ECN/PCN No.: R0518

Product Description:
5G/4G/LTE Adhesive-Mount Blade Antenna

Abracon Part Number / Part Series:
AECB1102X

Prior to Change:

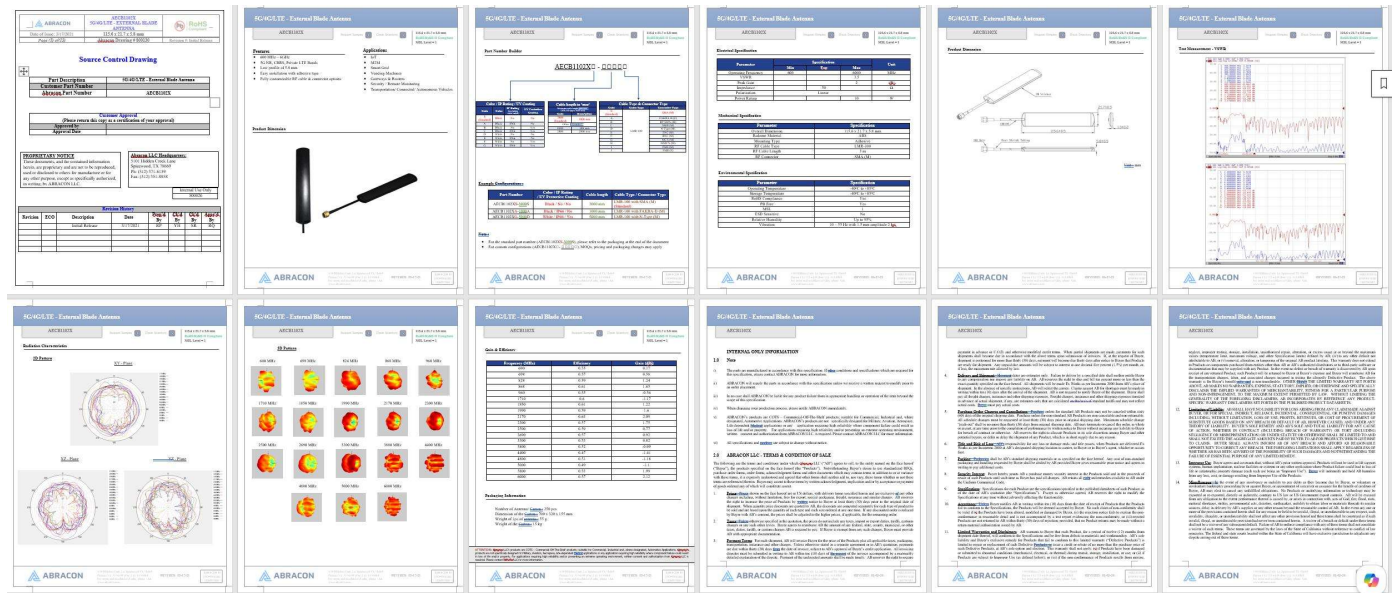
Cause/Reason for Change: Added IP66 option to ordering table & updated document layout
